# UNITED STATES PATENT AND TRADEMARK OFFICE

APPLICATION NO.	FILING DATE	FIRST NAMED INVENTOR	ATTORNEY DOCKET NO.	CONFIRMATION NO.
10/073,668	02/08/2002	Heinrich Englert	P6608.0US	4591
30008	7590	11/16/2005	EXAMINER	
GUDRUN E. HUCKETT DRAUDT LONSSTR. 53 WUPPERTAL, 42289 GERMANY			GOODMAN, CHARLES	
			ART UNIT	PAPER NUMBER
			3724

## Office Action Summary

### **DETAILED ACTION**

Fig. 7

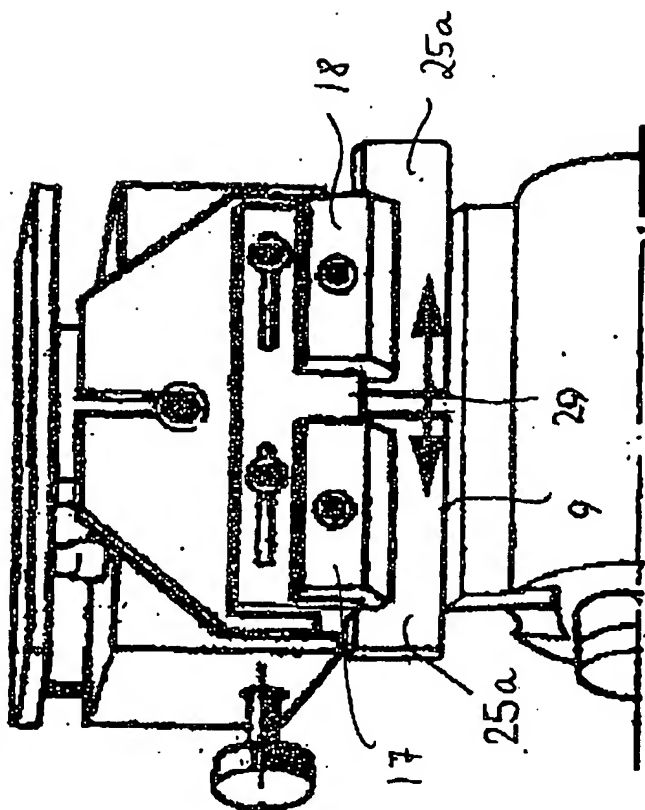
1. The Amendment filed on 8/24/2005 has been entered.
2. The drawings were received on 8/24/05. These drawings are not accepted because they introduce new matter. Contrary to Applicant's assertions, the depiction shown in the resubmitted Fig. 7 is not the only manner that complies with the specification description. For example, the stone members may be profiled and the minimal spacing does not have to be to the extent shown in Fig. 7, i.e. it could be larger or smaller.

3. The drawings are objected to under 37 CFR 1.83(a). The drawings must show every feature of the invention specified in the claims. Therefore, the arrangement with at least two jointing stone members (claims 6-7) must be shown or the feature(s) canceled from the claim(s). No new matter should be entered.

- i. Claim 6 is vague and indefinite in that it is not clear what the claim encompasses. Where is this shown in the drawings? What is the scope of the claim since such may not be ascertained without a corresponding showing in the drawings? Moreover, what is the claim referring to when claim 1 sets forth that the length of the stone is greater than the cutting edge? How is it possible or defined such that two stone members would comply with the requirements of claim 1?

A proposed drawing correction or corrected drawings are required in reply to the Office action to avoid abandonment of the application. The objection to the drawings will not be held in abeyance.
